Permit Modification Fact Sheet

Permit Number:	WI-0063533-02-1
Permittee Name:	Central Sands Dairy LLC
Address:	N15927 CTY G
City/State/Zip:	Nekoosa WI 54457
Discharge Location:	NW ¼ Section 12 T20N R4E, Town of Armenia, Juneau County
Receiving Water:	Central Wisconsin River Basin And Groundwaters of the State

Subject: Phase 2 Groundwater Monitoring at Central Sands Dairy, LLC, SW¼, Sec 12, T20N, R4E,
Armenia Township, Juneau County

Central Sands Dairy LLC Groundwater Monitoring

Figure 1: Air photo showing potential sources of contamination, Phase 1 wells (in red) and proposed Phase II wells (in yellow). See Table 1 for explanation.

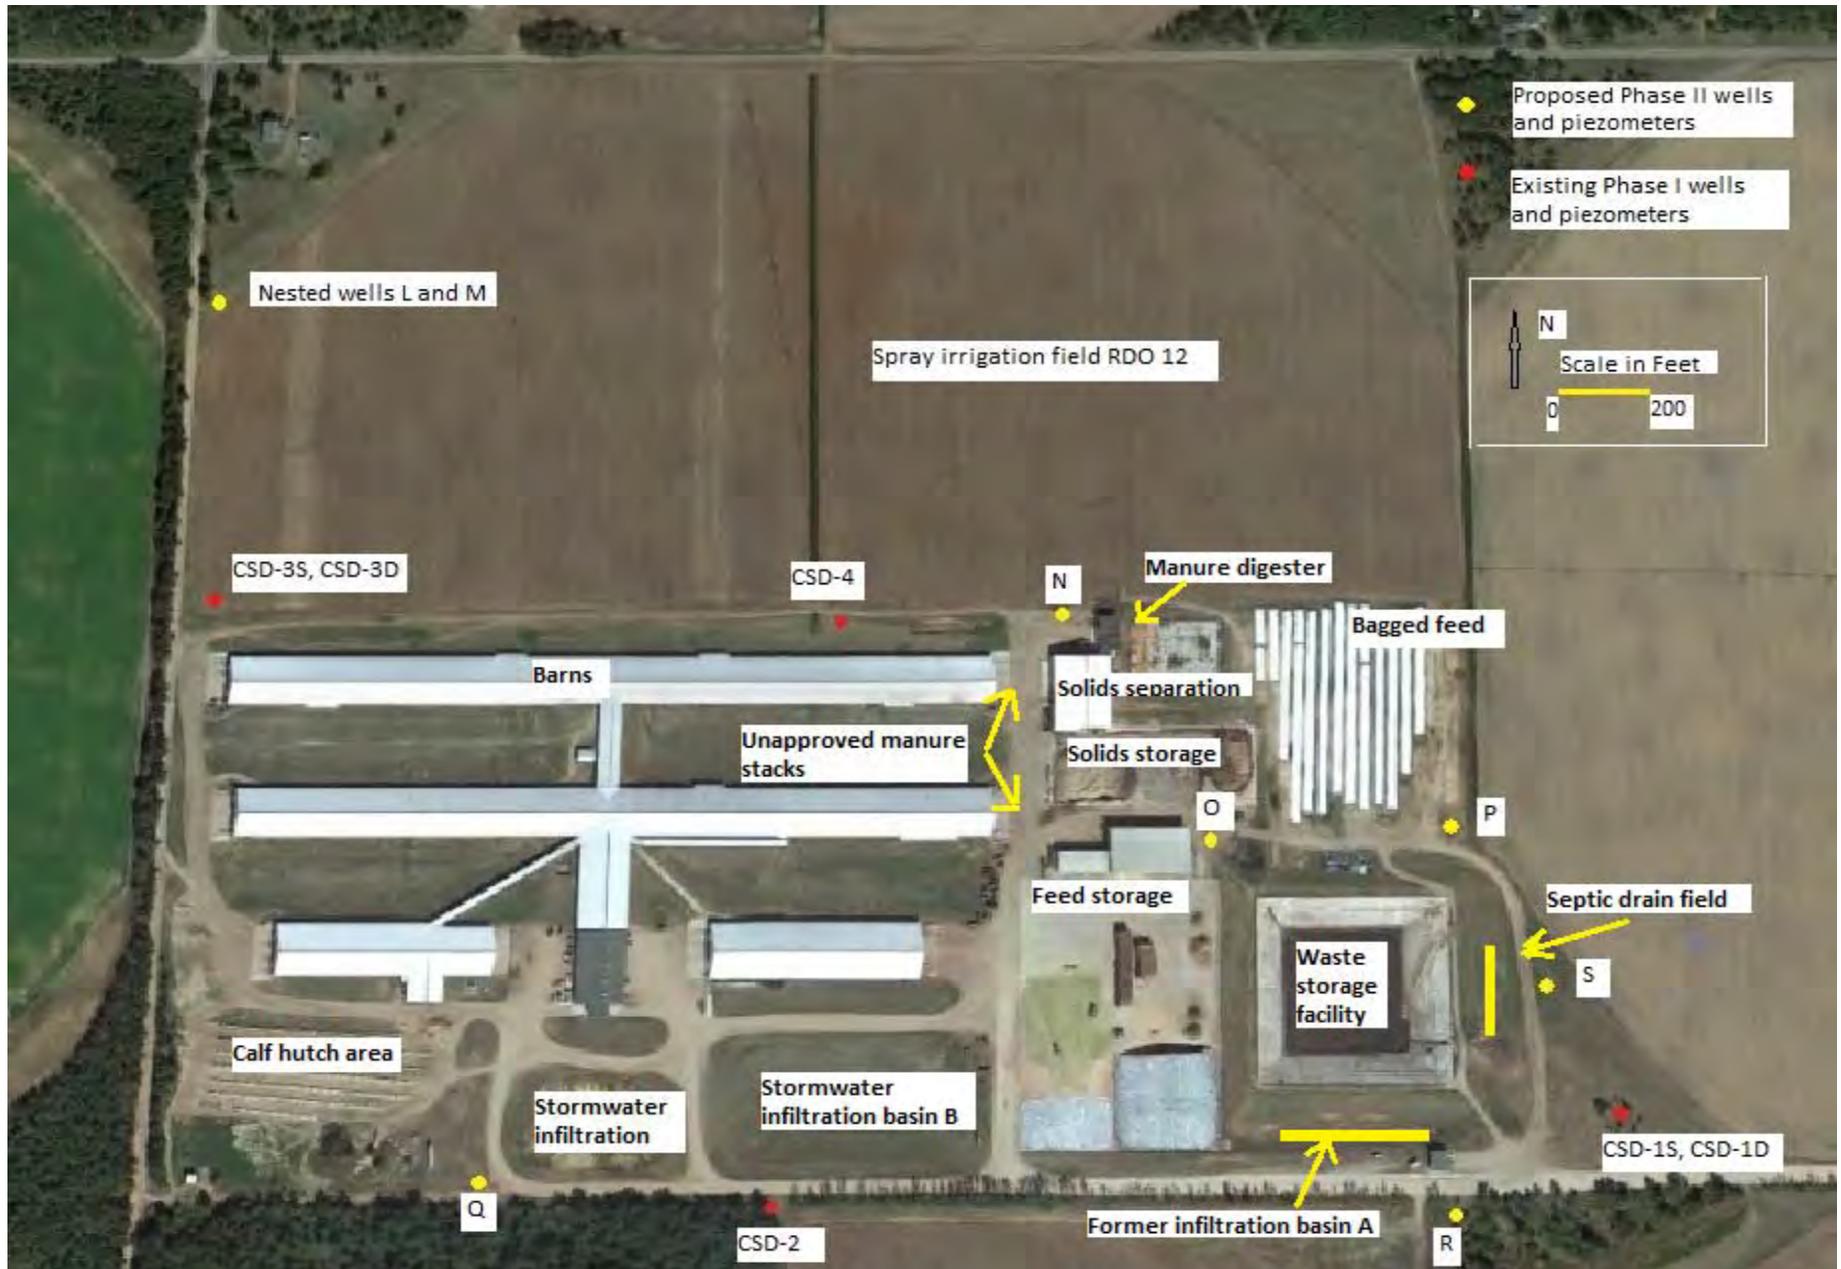
Review of sample analytical results from Phase 1 monitoring wells show unknown, onsite sources of ammonia/ammonium (ammonium-N) and nitrate have led to groundwater quality standard exceedances. Seven additional water-table wells and one additional piezometer are recommended. The proposed Phase II well locations will build on Phase 1 to define sources and help determine what remedies, if any, are necessary. Potential sources and recommended monitoring for each are listed in Table 1. Existing Phase I wells (red dots) and recommended Phase II wells (yellow dots) are shown in figure 1.

Sources	Monitoring Justification	Proposed wells
Calf Hutch Area	Up to 300 calves have been housed at the site. Calf hutches are set directly on the ground and may be contributing nitrate to groundwater. The source of high nitrate levels in CSD-2 maybe from the Calf Hutch Area. Proposed monitoring well Q is located downgradient of the calf hutch area.	Q
Winter manure stacking sites	Last winter manure was stacked next to the doors of the barns on the ground. Proposed well O is located.	O
Manure solids separation building	Inadvertent releases or structural aspects of the facility may be a source nitrate to groundwater. Proposed wells distinguish a number of structures from the WSF; monitoring well N is upgradient, O and P are downgradient.	N, O and P
Manure digester	Inadvertent releases or structural aspects of the facility may be a source nitrate to groundwater. Proposed wells distinguish a number of structures from the WSF; monitoring well N is upgradient, O and P are downgradient.	N, O and P

Bagged feed	The bags rest directly on the ground may be a source of nitrate to groundwater. Proposed monitoring well P is located downgradient.	P
Sand storage pad	Sand for bedding is separated from manure and stored without a cover, on a concrete pad which may be a source nitrate to groundwater. Proposed wells distinguish a number of structures from the WSF; monitoring well N is upgradient, O and P are downgradient.	N, O and P
Septic drain field	The recently identified septic drain field east of the WSF may be the source of ammonia in groundwater in wells CSD-1S and CDS-1D. Proposed monitoring well O is upgradient; well S is downgradient.	O and S
Waste storage facility (WSF)	Based on Phase 1 monitoring results, the bottom of the WSF (or pond) is sometimes in contact with groundwater. The WSF may be the source of	O and R

ammonia in groundwater in wells CSD-1S and CSD-1D. Proposed monitoring well O is upgradient, CSD-1S, CSD-1D and R ¹ are downgradient and separated from possible impacts from the septic drain field.	
Feed storage pad and bunker and infiltration basin A	Runoff from the feed storage pad and bunker are currently routed to the WSF. At one time, some of the runoff was routed to infiltration basin (A) next to the WSF. The consultant identifies residual nutrients in the basin as a potential source of ammonium. No additional wells to distinguish this source from the WSF are proposed.	None
Unlined barn stalls	The barns have concrete scrape alleys and cows are bedded on recycled sand placed directly on the ground. The unlined stalls may be a source of nitrate to groundwater. Proposed well R is located downgradient.	R
Land application of manure on field RDO-12	Elevated levels of nitrate in CSD-4, located upgradient of the facility and downgradient of spray irrigation field RDO-12, may indicate that land application of nutrients is impacting groundwater quality. Proposed monitoring well L and piezometer M are upgradient wells. Proposed monitoring well P is downgradient.	L, M and P

New well locations should take into consideration normal site activities and convenience of operation. High traffic areas should be avoided. All wells and piezometers (Phases I and II) should be sampled at least quarterly for the following parameters: total dissolved solids, chloride, chemical oxygen demand, ammonium/ammonia, total Kjeldahl nitrogen, total organic carbon, total coliform bacteria (count), E. coli (count) nitrate (nitrate+nitrite), and potassium. Quality Assurance/Quality Control samples should be included in the work plan. Sample analytical results may indicate that alternative concentration limits be determined.

Figure 2: Approximate locations of Phase I (existing) groundwater monitoring wells and groundwater flow direction for December 18, 2015 (from RJN Environmental Services Report dated December 23, 2015).

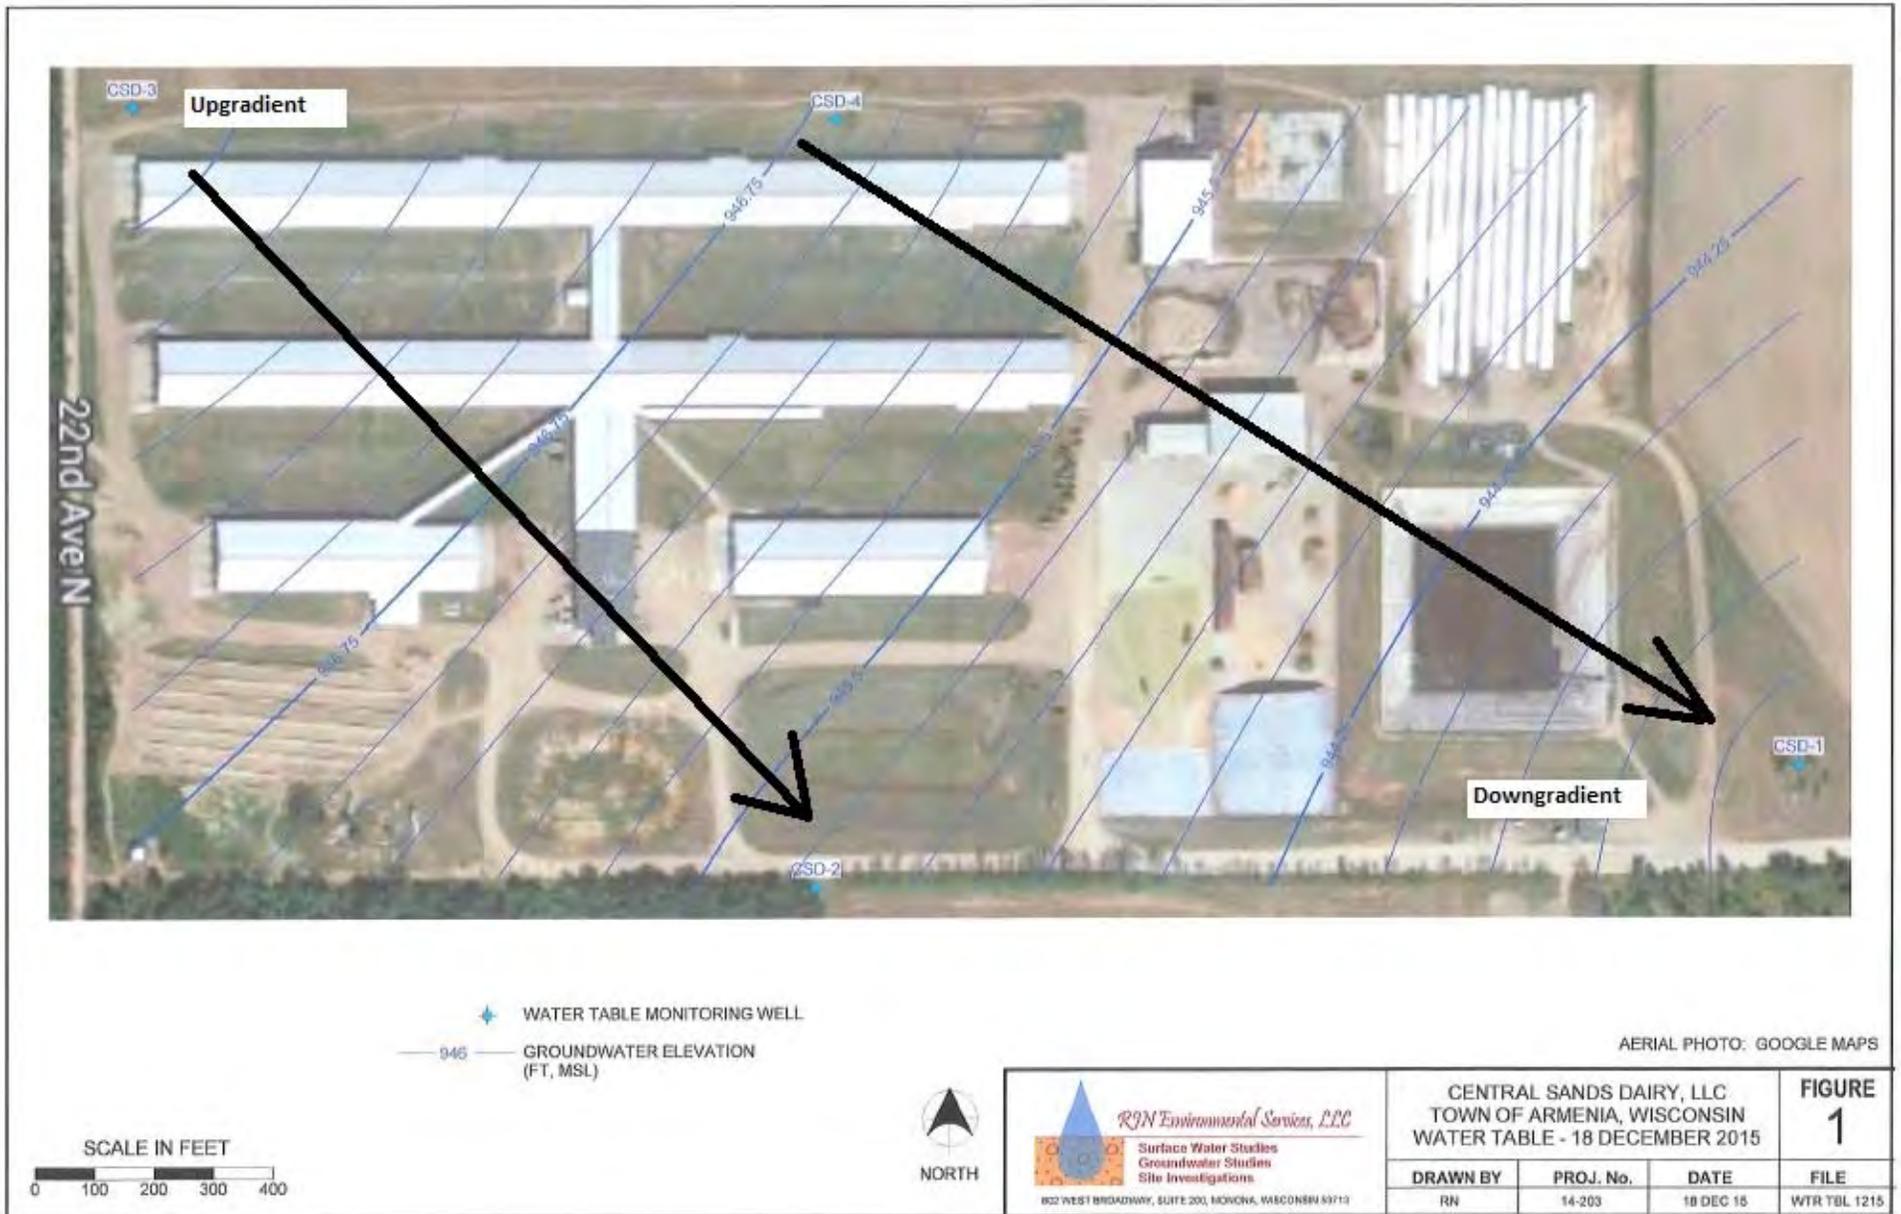
Four water-table monitoring wells and 2 piezometers were constructed in October of 2014 (referred to as Phase I in documents). The locations of Phase 1 wells and piezometers are shown in red on figure 1. Piezometers were paired with water-table wells to determine vertical groundwater flow and changes in groundwater quality with depth. Paired wells are referred to as nested wells. Nested wells CSD-3S and CSD-3D are located upgradient of the facility; nested wells CSD-1S and CSD-1D are located downgradient. Horizontal groundwater flow across the facility is from the northwest toward the southeast (see figure 2).

drain field. The WSF has been cleaned, inspected and repaired. However, groundwater elevation data from Phase I wells show that the water-table rises above the bottom of the WSF creating the potential for release of ammonium to groundwater. Table 3 provides the Phase 1 groundwater elevation data used for determining groundwater flow direction and proposed Phase II well locations [Note: This table includes data from voluntary groundwater monitoring wells (abandoned on recommendation of CSD consultant) that preceded the Phase 1 plan and are labelled MW-1, MW-2 and MW-3.]
